Lighting recommendations for the Social Security Administration Frank Hagel Federal Building in Richmond CA

Final Report October 1999

Final Report

Figure 3. Illuminance distribution from indirect lighting system. Values calculated using Lumem Micro Version 6.0.

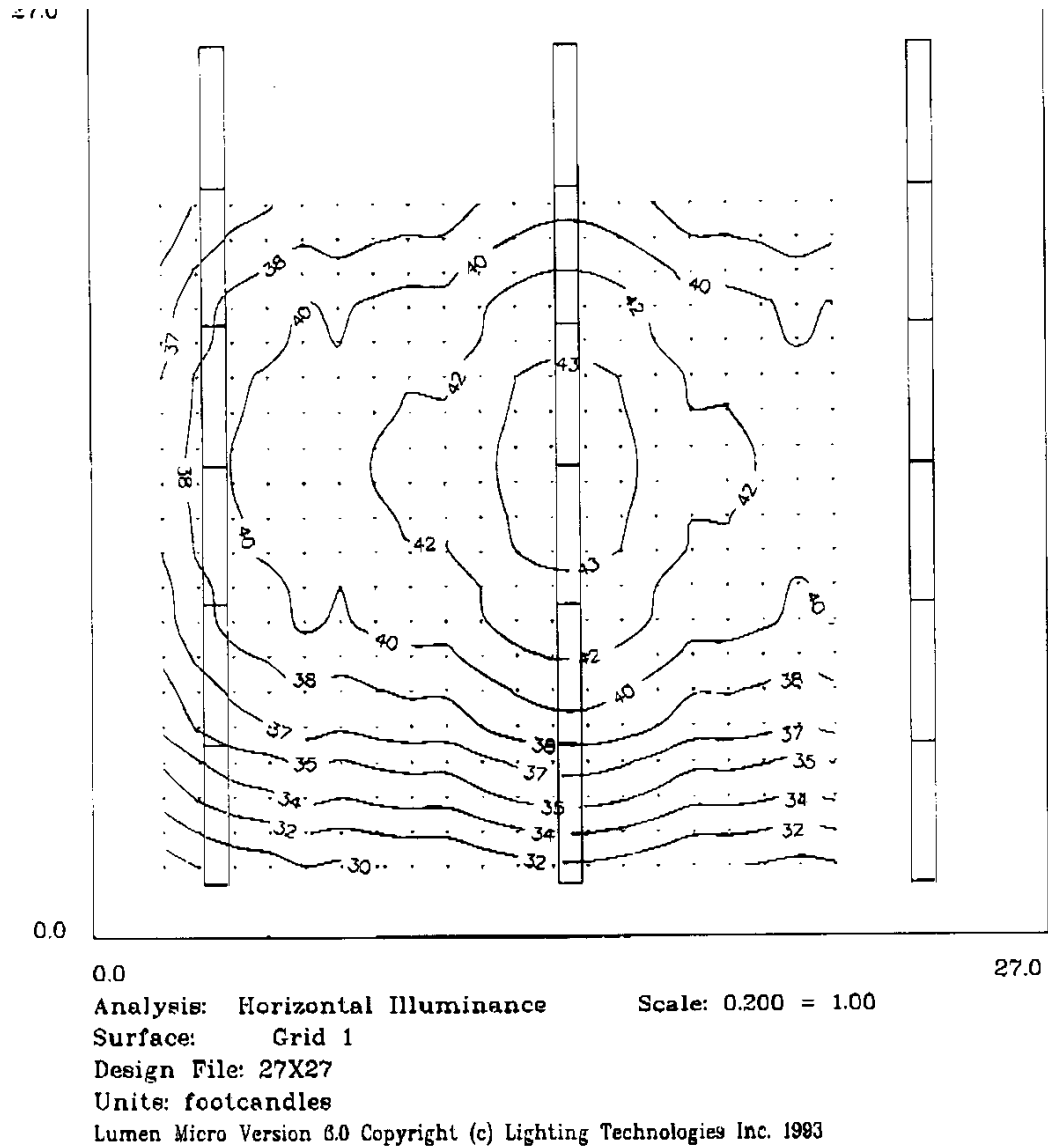
The specific indirect lighting solution that we recommend will use rows of indirect luminaires with only one lamp per 4 ft section. To provide more accurate information, we have selected a particular manufacturer (Finelite) and product (Series 1) for modeling the lighting impact of the indirect lighting system. Other manufacturers may have similar products with similar performance characteristics that would perform satisfactorily also. The technical specifications (in PDF format) for each of the recommended fixture types is given as an attachment to this report. (Use of a specific company name does not denote endorsement of this or any other product. See disclaimer at end of report).

Fixture type: 24' Finelite Series 1 fixture with EP reflector
Lamp: 1 T-8 per 4 ft. section, 2850 lumens
Ballast: 2-lamp electronic ballast with ballast factor = 1.25
Suspension length: 21 inches
Light maintenance factor: .75
Ceiling/wall/floor reflectances: 80/50/20

Average illuminance: 38.7 footcandles
 Minimum: 28 footcandles
 Maximum: 44.1 footcandles

It should be noted that this solution requires a ballast with a high ballast factor (1.25) to obtain satisfactory light levels. Use of normal ballast factor will result in lower illumination levels. It should be noted that the above analysis does not include the effects of the partitions which will reduce the delivered light levels by about 20%.

To provide higher light levels than the 38 footcandle average will require supplemental task lights which could either be located under the storage cabinets or as articulated arm task lights that are mechanically connected to the desks. Because of variability and user preference, this report does not make specific recommendations for type of task light. The articulated arm task lights used in other portions of the building would serve this purpose well.

Because there is only one lamp per 4 ft section of fixture with this economical solution, there is no opportunity for providing multi-level switching of the lighting system. It is recommended that the lights be switched in rows.
